# Access Compliance Report

### (Curb Ramps)

Intersection ID: 28654	Main Street: HAMPTON_PLACE_DR	Cross Street: SHADYSIDE_CT	Location: S
ADA ID: ADEA2135FA7E	Ramp Type: Perp	Initial Pass/Fail: Fail	Overall Compliance: No
Severity Score: 10			
Codes/Mitigation Info/Possible Solution		Field Measurements/Component Compliance

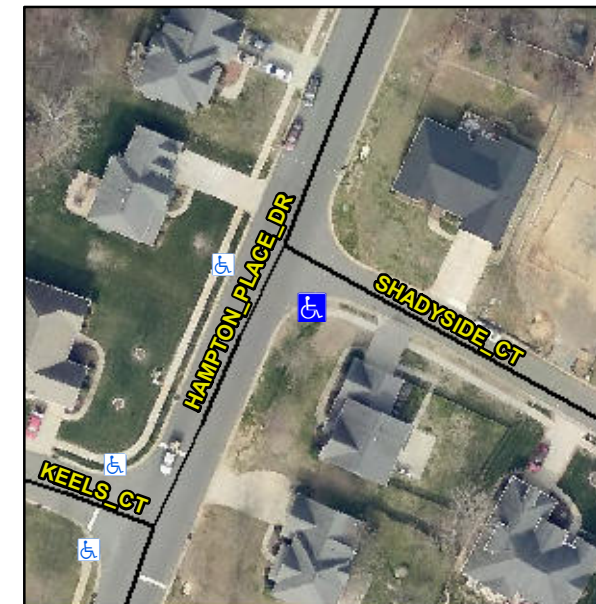
**Not Found, R304.5.1, R304.5.3**

Compliance	Description	Data	Compliance	Description	Data
N/A	Ramp Length (in)	49.0	Yes	Ramp Slope (%)	5.1
No	Ramp Width (in)	45.5	No	Ramp XSlope (%)	2.8
N/A	Flare Type LT	N/A	N/A	Flare Type RT	N/A
N/A	Flare Slope LT (%)	N/A	N/A	Flare Slope RT (%)	N/A
N/A	Flare Traversable LT?	N/A	N/A	Flare Traversable RT?	N/A
N/A	Landing Length (in)	N/A	N/A	DWS Provided?	N/A
N/A	Landing Width (in)	N/A	N/A	DWS Contrast?	N/A
N/A	Landing Slope (%)	N/A	N/A	DWS Length (in)	N/A
N/A	Landing X Slope (%)	N/A	N/A	DWS Full Width?	N/A
N/A	Landing Curb? (Y/N)	N/A	N/A	DWS Offset (in)	N/A
N/A	Shared Landing?	N/A			
N/A	Gutter Ponding?	N/A	N/A	Gutter Slope (%)	N/A
N/A	Gutter Lip Ht (in)	N/A	N/A	Gutter X Slope (%)	N/A
N/A	Painted X Walk1?	No	N/A	Painted X Walk2?	N/A
	X Walk 1 Direction	To NW		X Walk 2 Direction	N/A
N/A	X Walk 1 Width (in)	N/A	N/A	X Walk 2 Width (in)	N/A
	X Walk 1 Slope (%)	1.3		X Walk 2 Slope (%)	N/A
	X Walk 1 X Slope (%)	2.6		X Walk 2 X Slope (%)	N/A

**Remove & Replace Entire Ramp.**
